Docket No. 50-336  
B18662

Millstone Nuclear Power Station, Unit No. 2  
Reply to Request for Additional Information  
Related to NRC Bulletin 2001-01

Reply to Request for Additional Information  
Related to NRC Bulletin 2001-01

Figure 1 Location of UT indications in Nozzle 21 from 2R14 Inspection

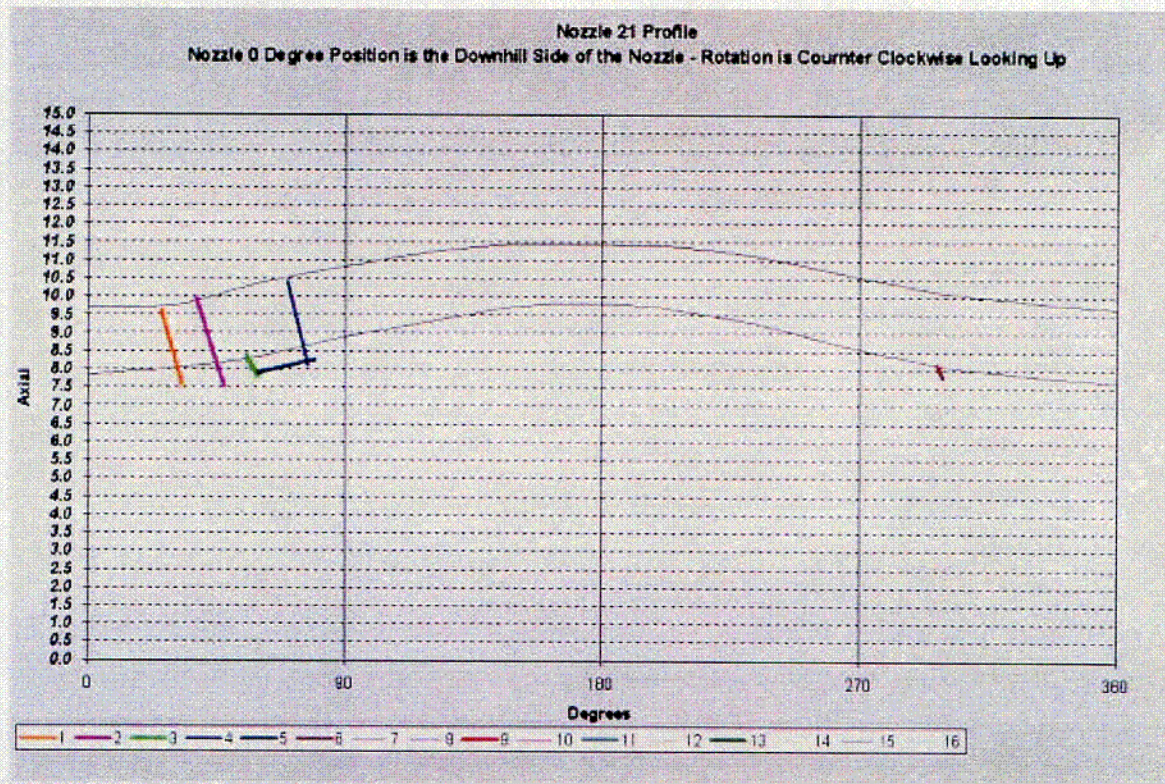
2. *The information in the three tables states that the location of each of the indications found is "OD downhill". The staff requests more specific information regarding the locations. If possible, please provide the information similar to that provided by in Figure 8 through 12 of the Root Cause Analysis Report for Davis-Besse dated April 18, 2002. These Figures are shown on the NRC website at:*

See Figure 1 through 3 on the following pages:
